SUNDRY NOTICES AND REPORTS ON WELLS

8. Well Name and No.
SEMU 128

9. API Well No.
30-025-34313-00-S4

SEMU BTD 128
API # 30-025-34313
P&A Procedure

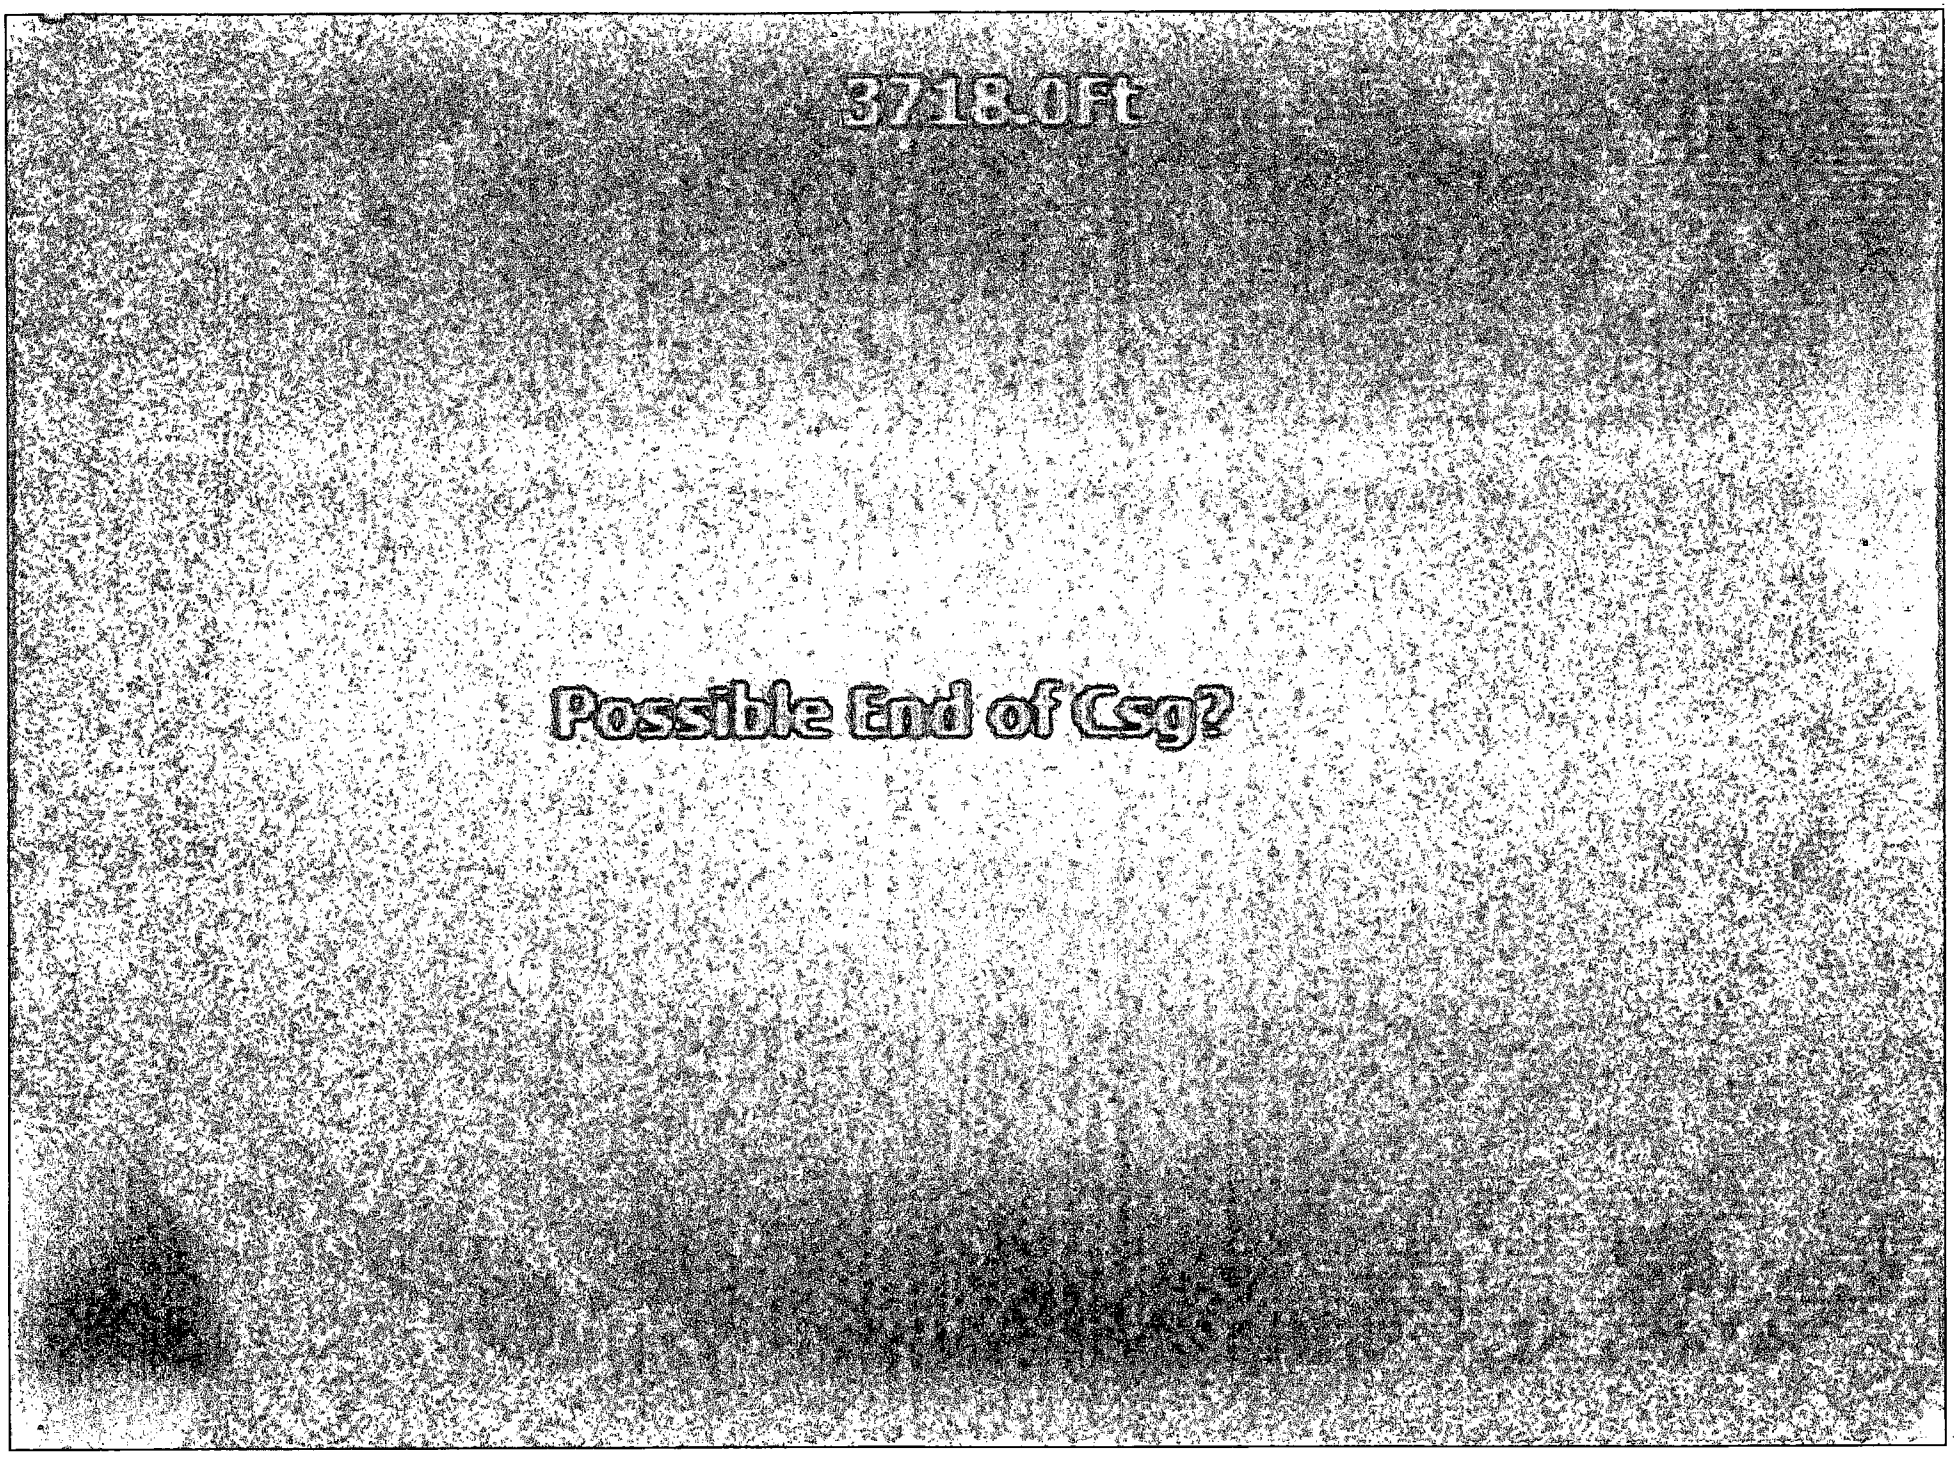
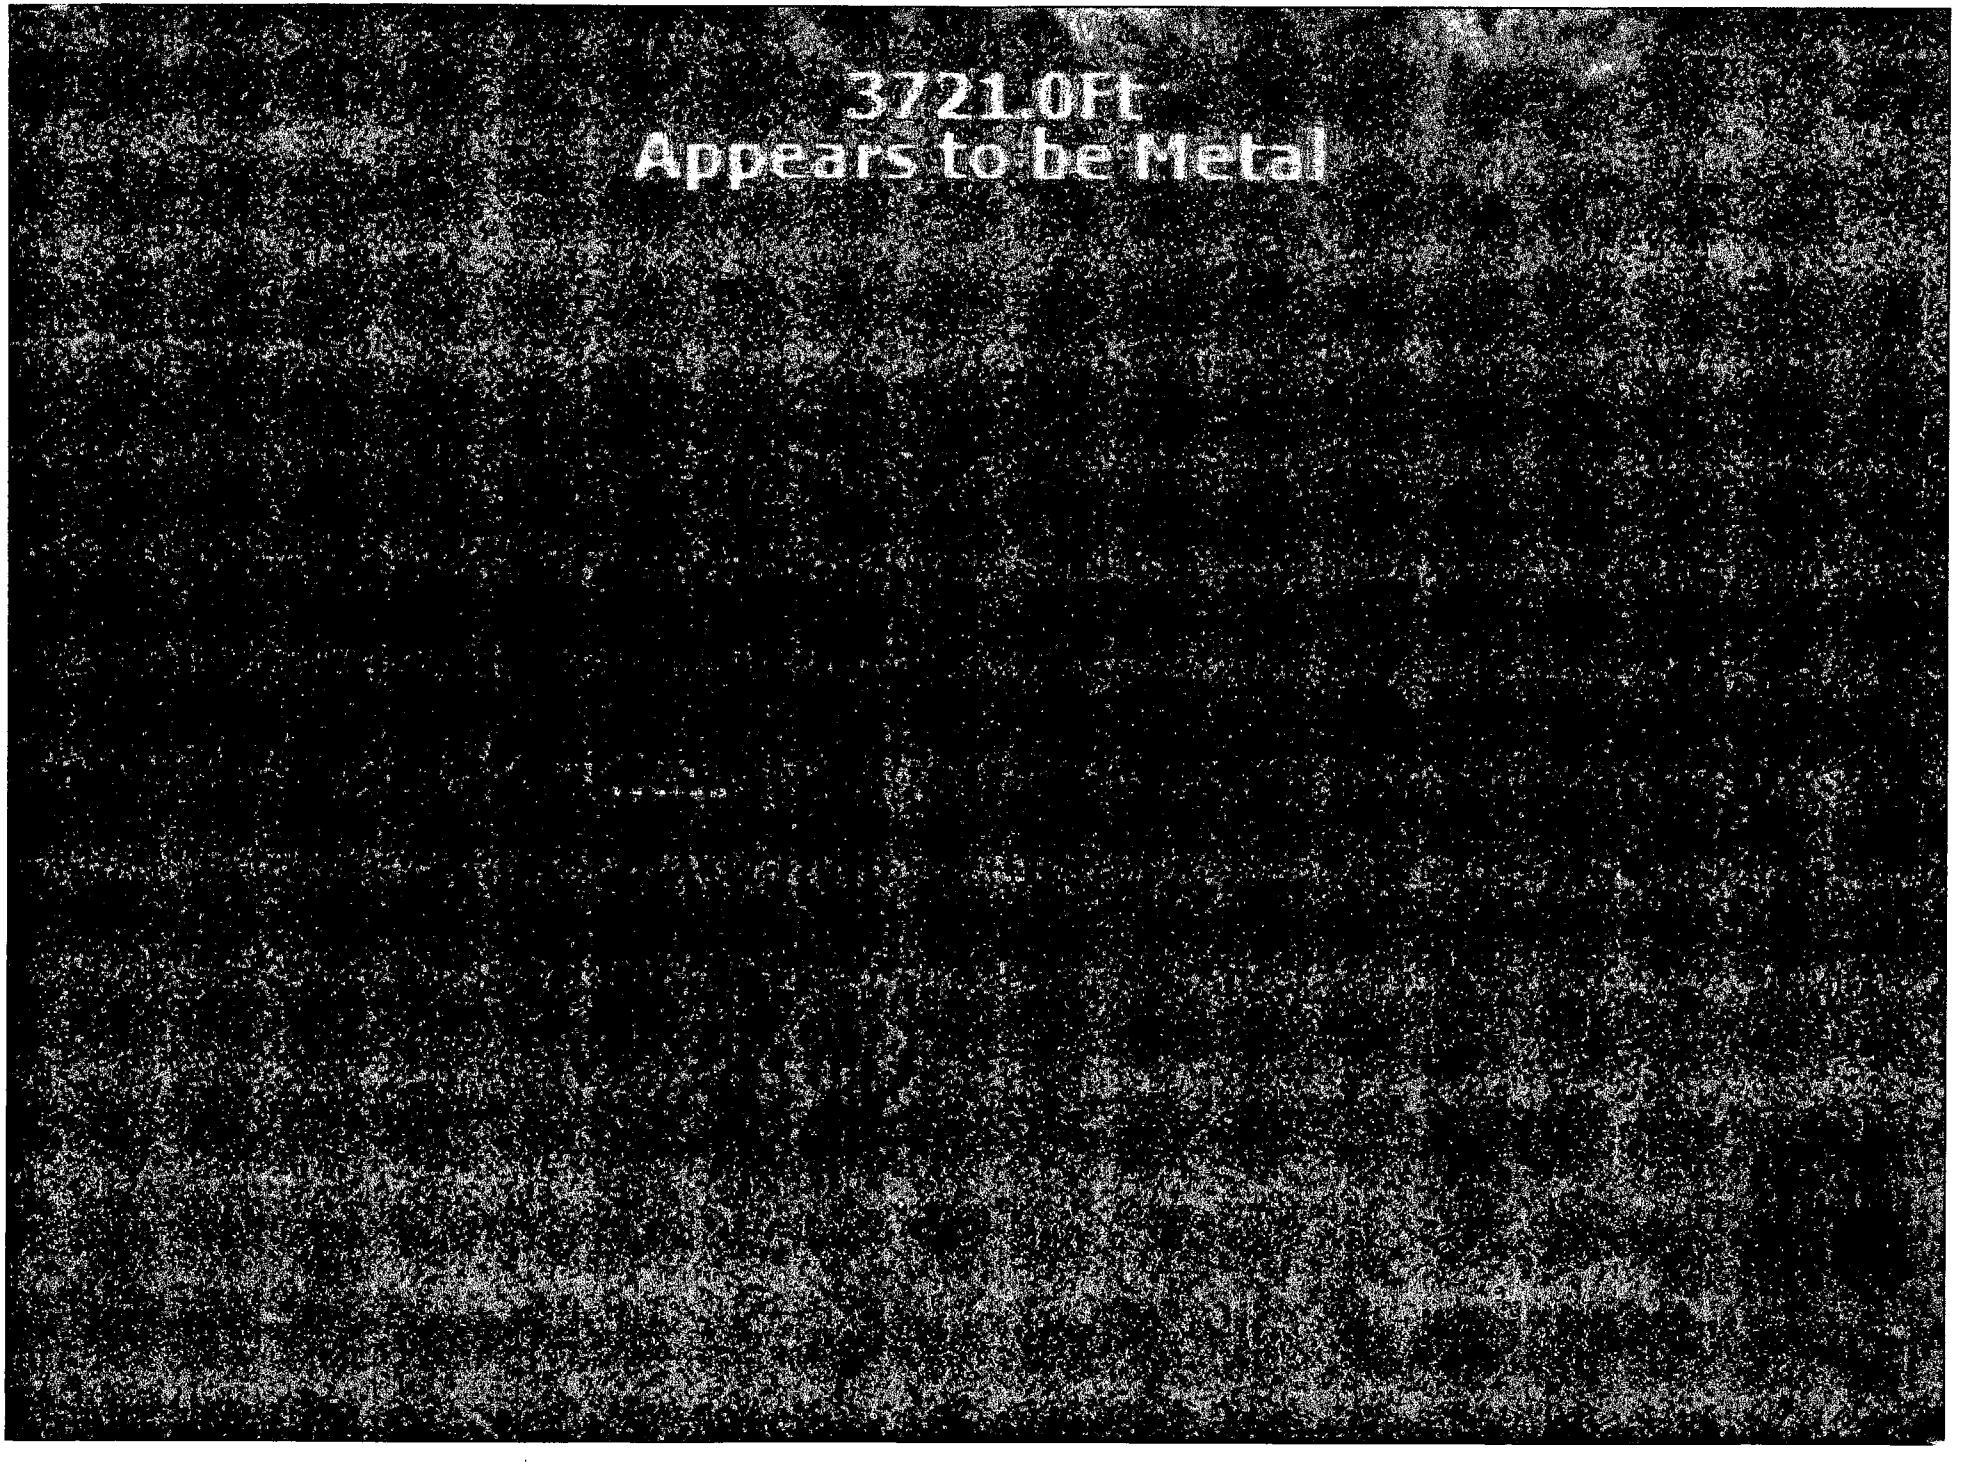
MSB/OCD 2/17/2015
Recommend cmt plug start @ 3718 +/- (IF ALL ATTEMPTS TO ACHIEVE LOWER DEPTHS FAIL.)
